PRODUCT CHANGE NOTIFICATION PCN-000486

Date: 2APR2018

Appendix A – Revised Datasheet – RClamp3346P

RClamp3346P Low Capacitance RClamp® 6-Line ESD Protection

Outline Drawing - SGP2708N7

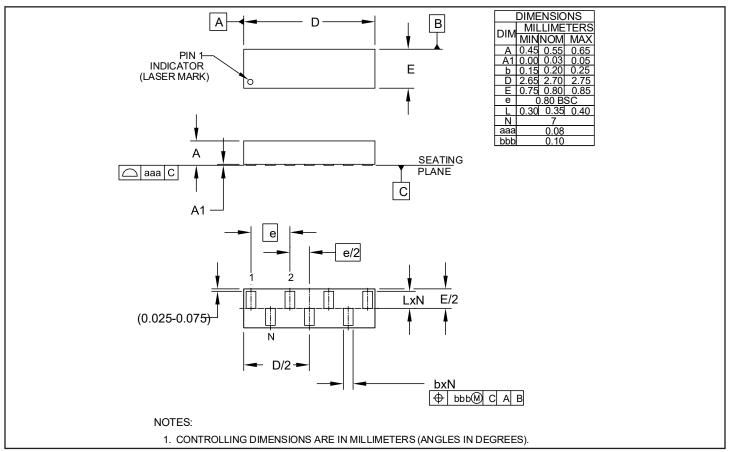
_	_			_				
	ntech Corporatio					Canada		
 Semtech Canada Corporation, 4281 Harvester Road, Burlington, Ontario L7L 5M4 Canada Semtech Irvine, 5141 California Ave., Suite 100, Irvine CA 92617 								
Semtech Neuchatel Sarl, Route des Gouttes d'Or 40, CH-2000 Neuchatel Switzerland								
Semtech Bristol - EMEA Limited, Block B, St James Court, Great Park Road, Bristol BS32 4QJ, UK								
	Semtech Corpus Christi SA de CV, Carretera Matamorros Edificio 7, Reynosa, Tamaulipas, Mexico 88780							
	ntech Plano, 110	1 Resour	ce Drive, S					
					ge Details			
	umber(s) Affe p3346P.TNT	ectea:		ſ	Customer Part Number(s) Affected: 🛛 N/A			
An erro RClamp mass pi	03346P Datashe roduction since 2	o3346P da et to reflec 2012.	atasheet ct the phy	has been sical dimer	: eported. Semtech is updating sions of the released product. F			
IS NOW:	[Matches parts	released l	o mass p	roduction				
	DIM [mm]	MIN	NOM	MAX

l	А	0.45	0.55	0.65				
1				11		SEATING PLANE		
Was:			-	<u>. </u>		Ċ		
ſ	DIM [mm]	MIN	NOM	MAX	A1 —			
	А	0.47	0.50	0.53				
					Impact to Form, Fit,	Γ		
Chang	ge Classificatio	n 🗌 🗆	Major	Minor	Function	🗆 Yes 🛛 No		
Impa	ict to Data Shee	x t	🗌 Yes	🛛 No	New Revision or Date	⊠ N/A		
Noimp	t to Performa act to FFFQR ed to mass proc	of the p			Reliability: the datasheet to be consist			
Implementation Date Immediate			diate	Work Week	In line with implementation date			
Last Time Ship (LTS) Of unchanged product Not Applicable				Affecting Lot No. / Serial No. (SN)	All shipped material			
Sample Availability Updated datasheet attached			ched	Qualification Report Availability	Not applicable			
	orting Docum Updated Datas		Chang	e Validati	on/Attachments:
